HYDROLOGY K10/D15 2 PLANS

RE: PROJECT NO.#2908- VICTORY LOVE FELLOWSHIP CHURCH

RE: DRAINAGE PLAN FOR 50 X 75 BUILDING ADDITION TO VICTORY LOVE FELLOWSHIP CHURCH (K-10/D15) REVISION DATE OF AUGUST 31, 1987

RE: CERTIFICATE OF OCCUPANCY FOR VICTORY LOVE FELLOWSHIP CHURCH (K-10/D15) RECEIVED MAY 8, 1987

TITLE: PLAN VIEW
EXTENSION OF RCP CULVERTS
VICTORY LOVE FELLOWSHIP CHURCH
7201 CENTRAL AVENUE, N.W.

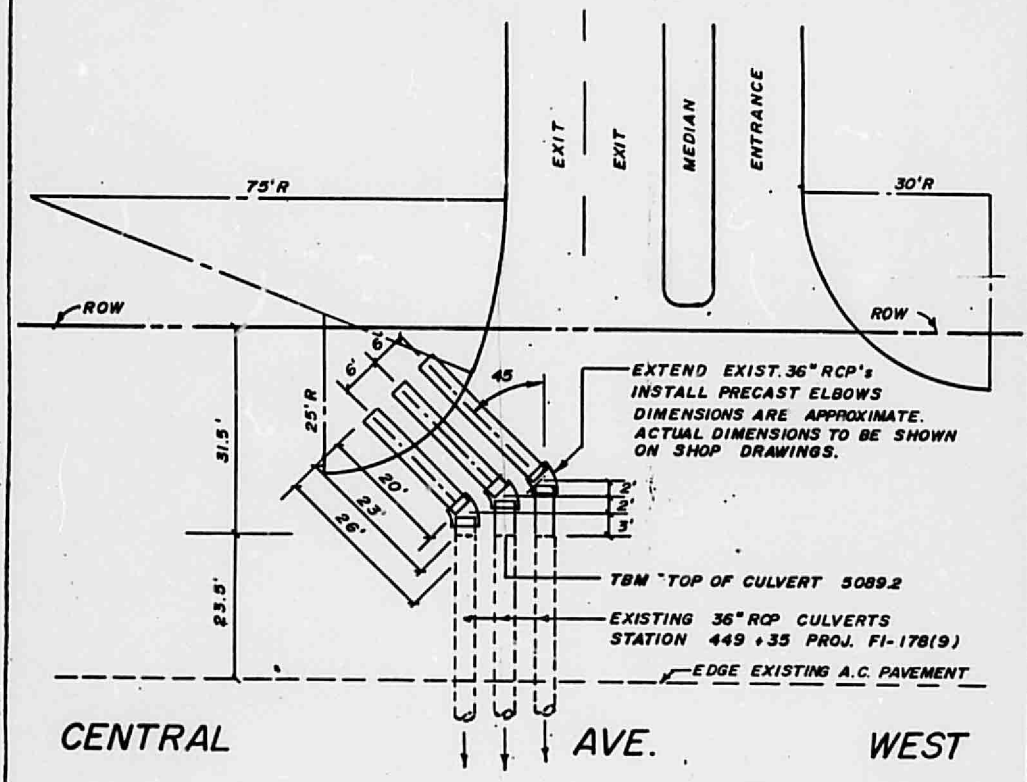
RE: APPLICATION FOR PERMIT TO EXTEND EXISTING 36-INCH RCP CULVERTS AT STATION 449+35, PROJECT NO. FI-178(9) TO FACILITATE DRIVEWAY ENTRANCE TO CHURCH.

It is proposed to extend the culverts at the same slope as the existing culverts. The 45-degree bend will be accomplished by a precast RCP Elbow equivalent to those manufactured by Hydro Conduit.
